**PROPOSED NEW FACILITY**  
 TAPPAN FIRE DISTRICT  
 135 WASHINGTON STREET  
 TAPPAN, NY 10983

**2022 LAND USE BOARD APPLICATION**

**Subject:** **Tappan Fire District**  
Prepreliminary/Preliminary/Final  
Site Plan and SEQRA Review  
135 Washington St, Tappan, NY  
77.11-3-4; CS Zoning District

Submission reviewed: Site Plan Approval Drawings dated January 12, 2022 by Atzl, Nasher, & Zigler PC

**SITE PLAN**

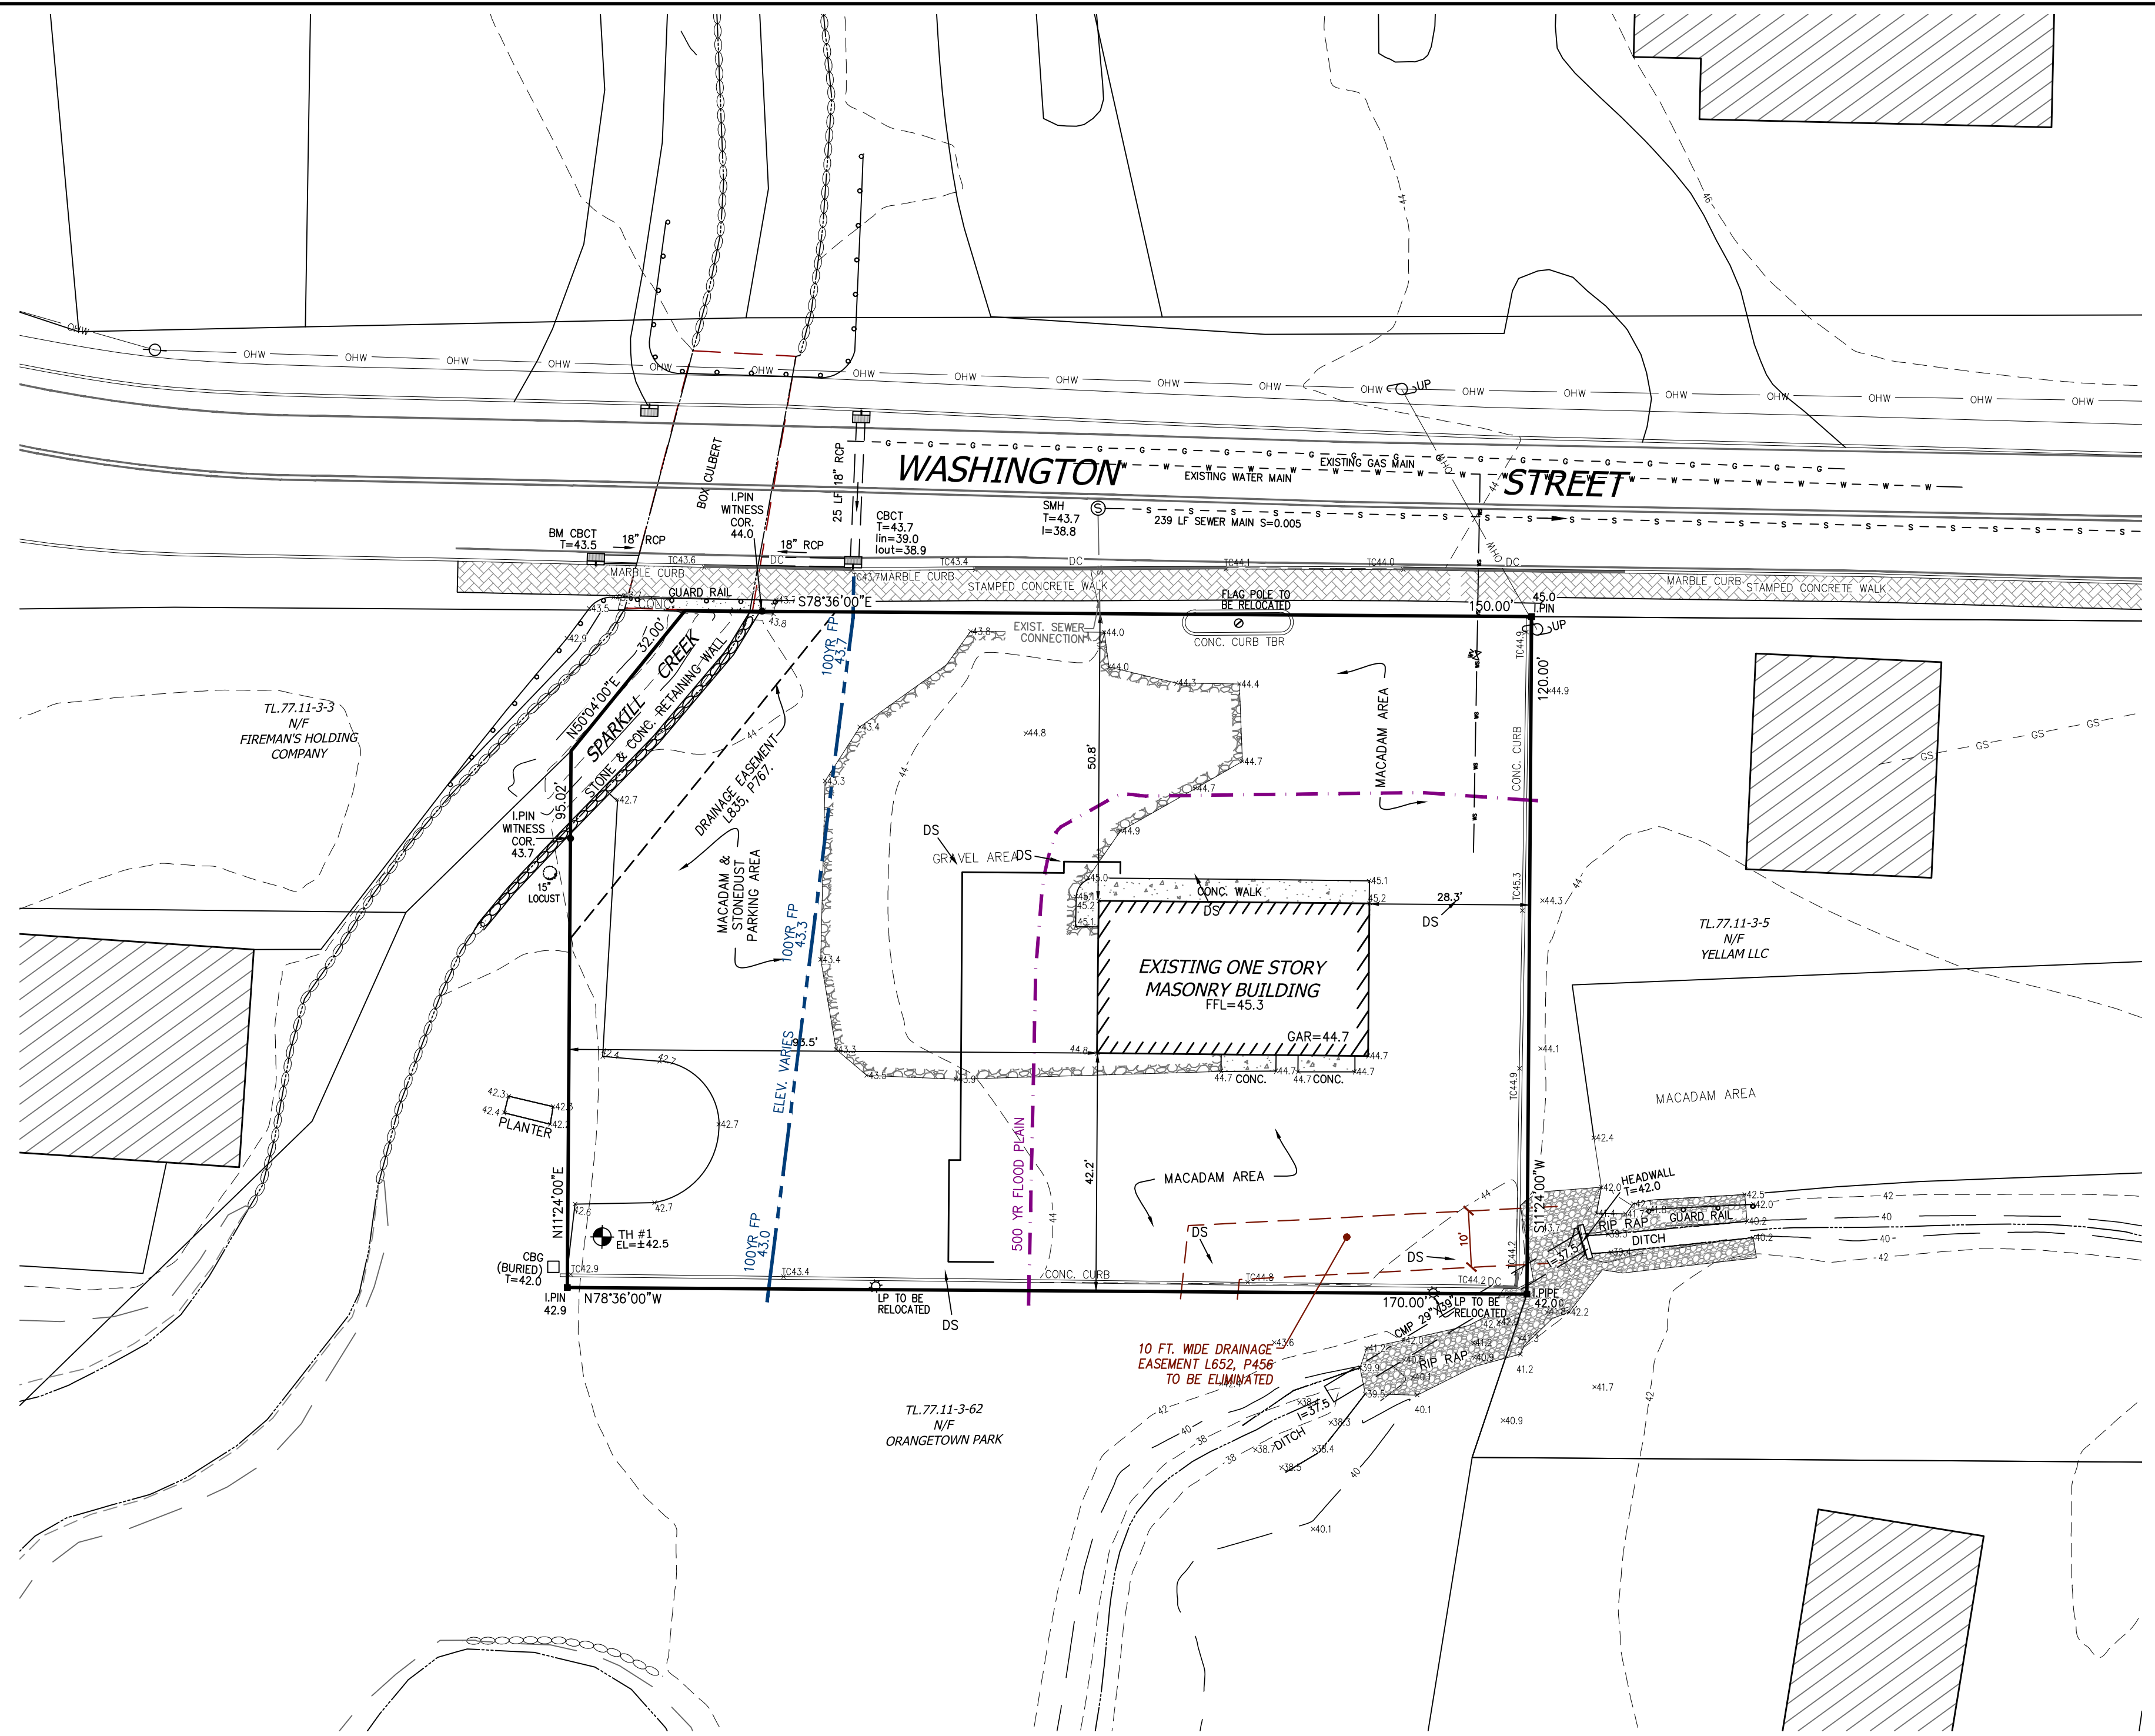
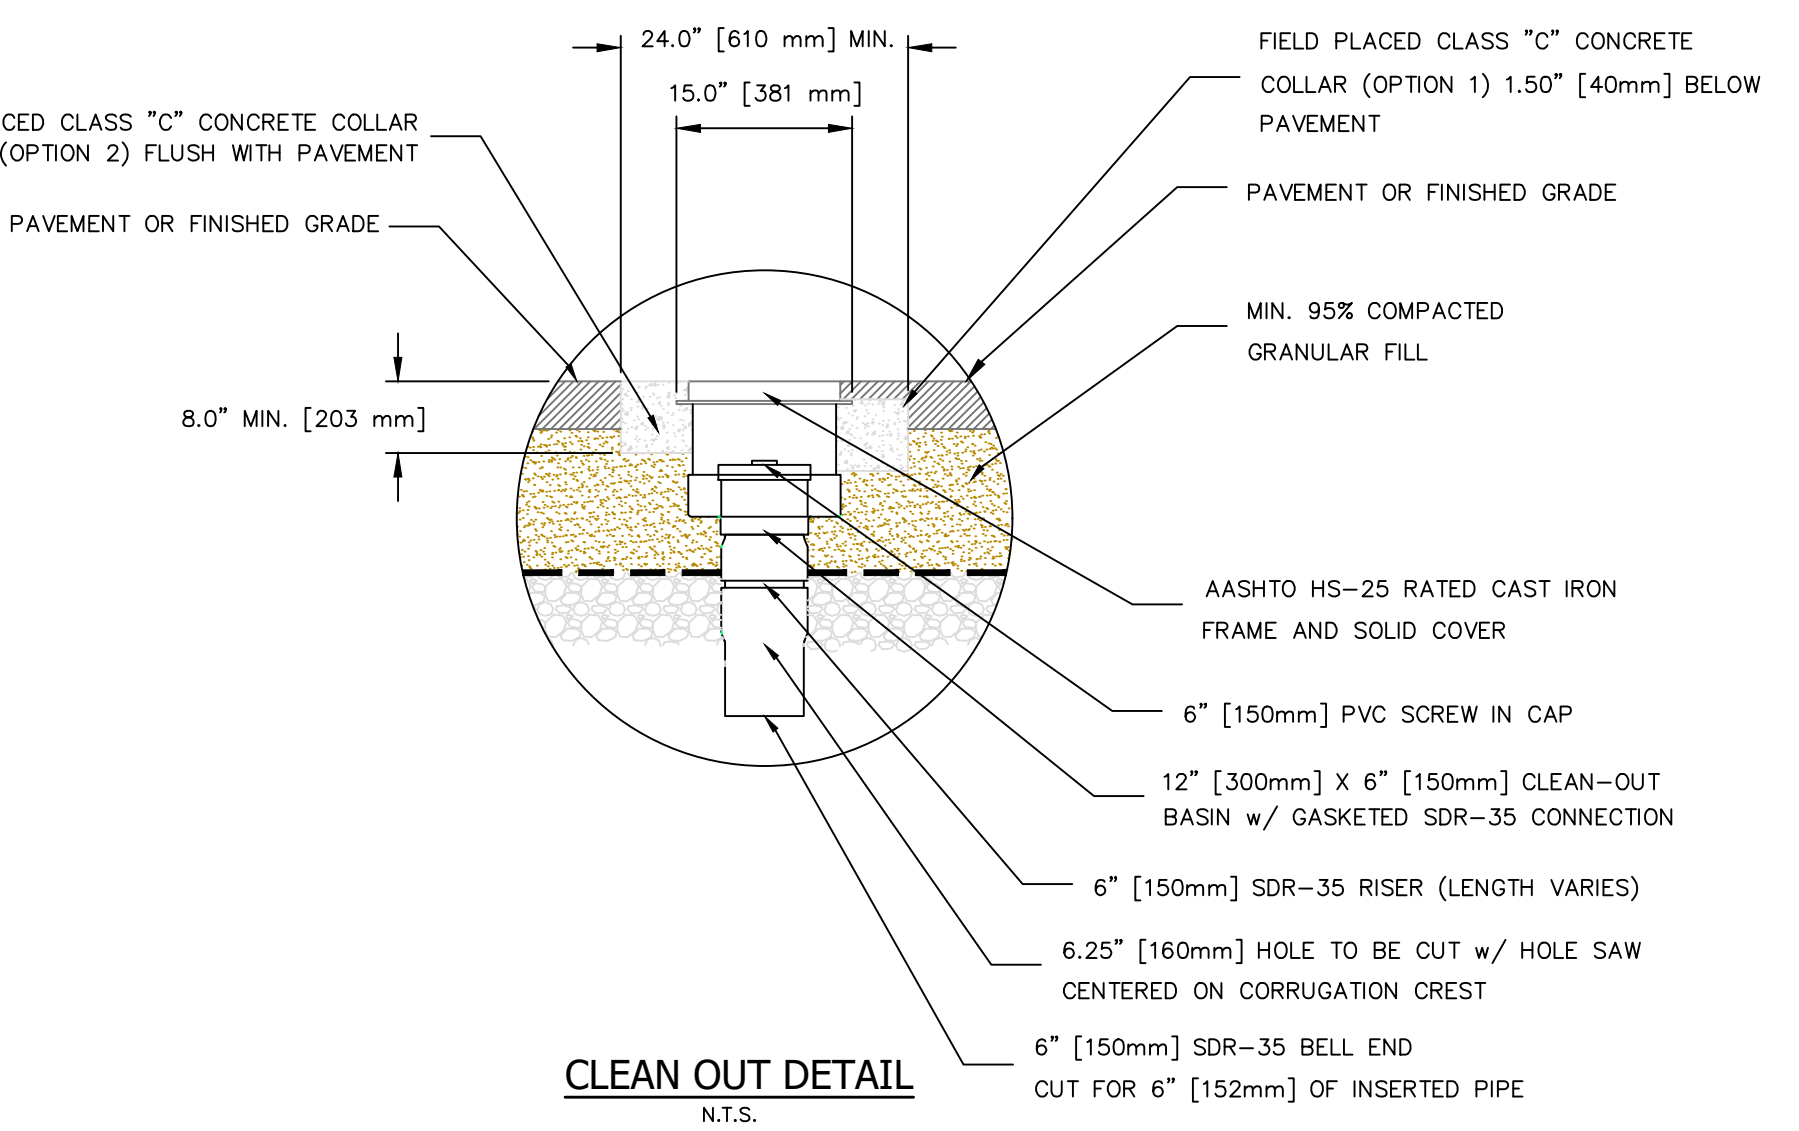
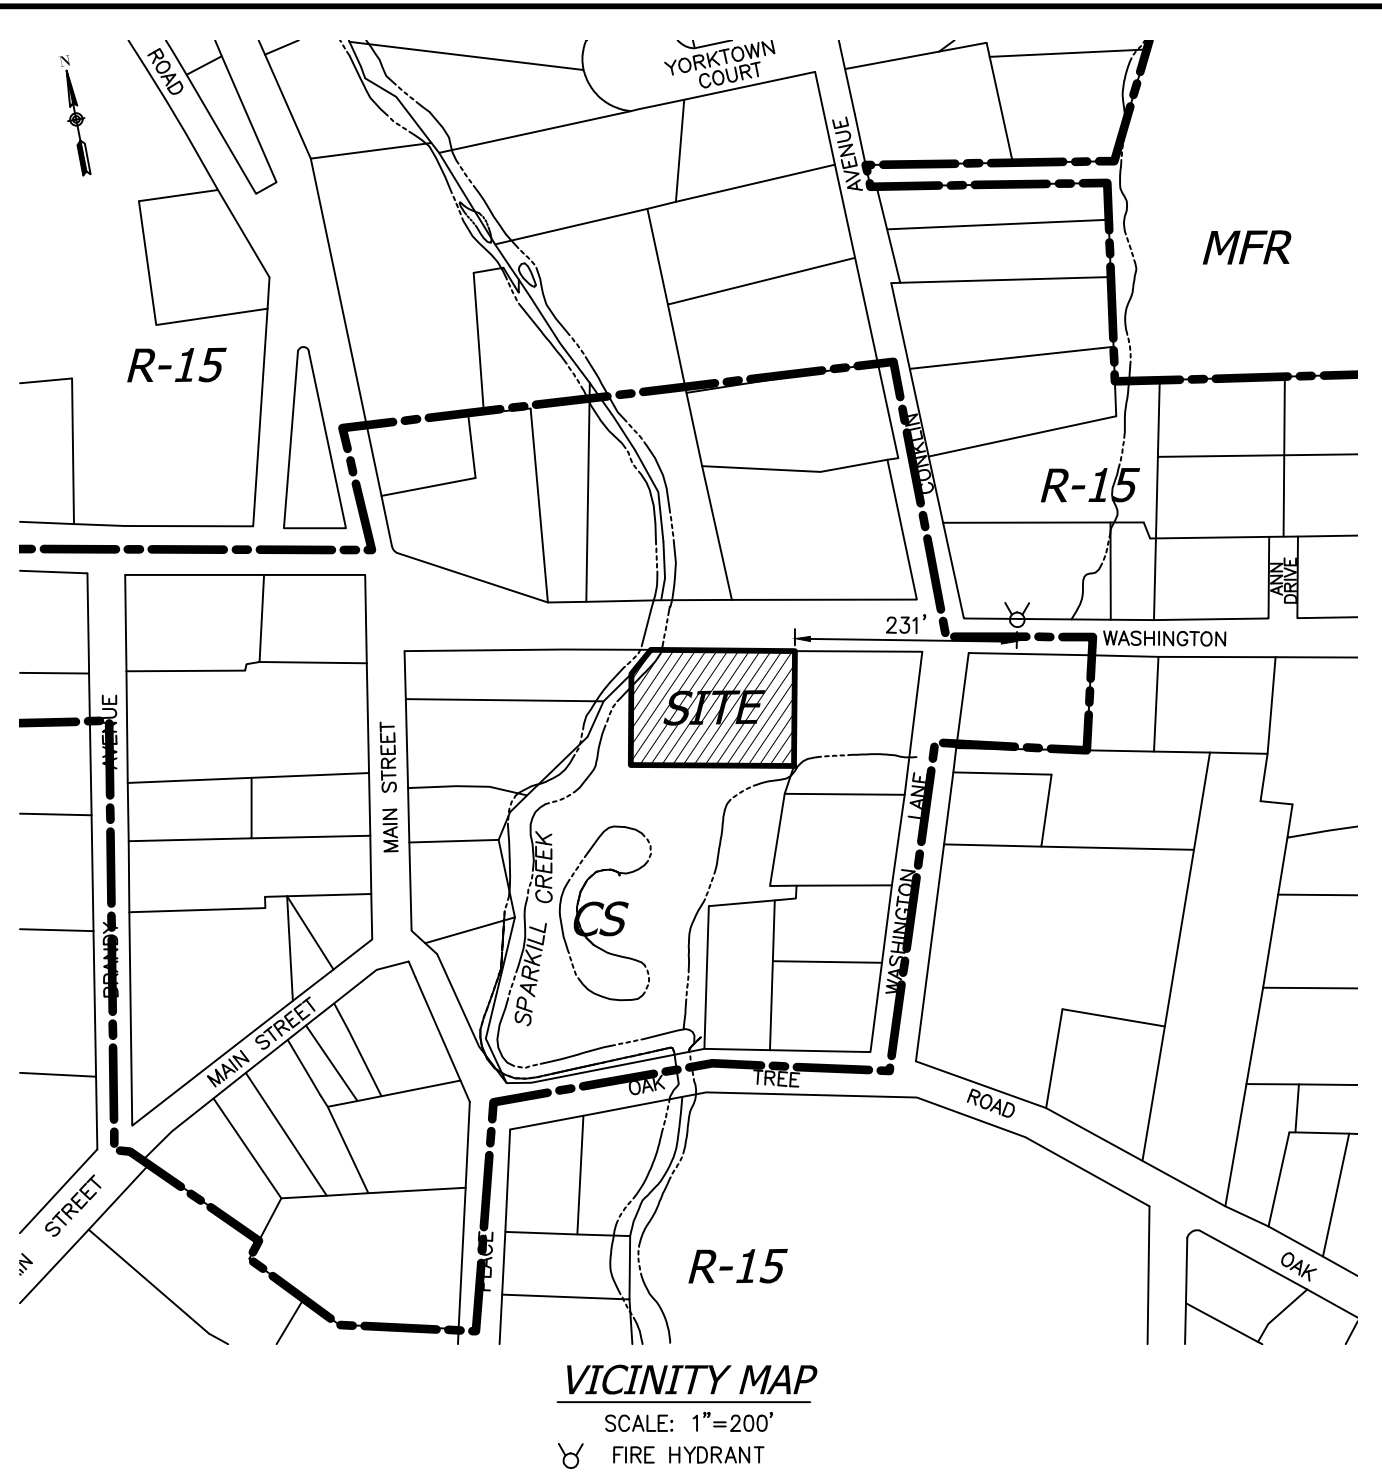
- 1.) Chapter 43, Zoning Board approval required as per Bulk Table 3.12  
Column 1: CS District, Column 2: Group GG, Column 3: Fire Station, Column 8:  
Front Yd 100' minimum w/ 45' proposed, Column 9: Side Yd 100' minimum w/  
12' proposed, Column 10: Total Side Yd 200' minimum w/ 79' proposed, Column

11: Rear Yd 100' minimum w/ 5' proposed.
- 2.) Chapter 2, Section 2-4(A) landscaping and lighting requires ACABOR approval.
- 3.) Chapter 12, Section 12-4(A) façade requires Historic Board approval.

- 4.) Chapter 21A, Section 21A-4(A) requires Planning Board approval.
- 5.) Most of site and partial building located in FEMA DFIRM (Federal Emergency  
Management Agency Digital Flood Insurance Rate Map) 500-year flood plain.  
Partial site located in 100-year flood plain. Requires DEC approval

- 6.) Provide elevations at lot corners
- 7.) Partial building in drainage easement. Obtain approval from persons/entity that  
use easement
- 8.) Provide directions arrows depicting drainage flow over property.

10.) Parking should be calculated at 1 space per 200 sf of gross floor area and calculations should be listed on site plan.

11.) Site plan indicates all roof drains shall be piped to basin. Indicate roof drain discharges locations on site plan.

2	3-28-22	PER OBZPAE COMMENTS 3-16-22
1	2-28-22	PER ARCHITECT
REVISION	DATE	DESCRIPTION
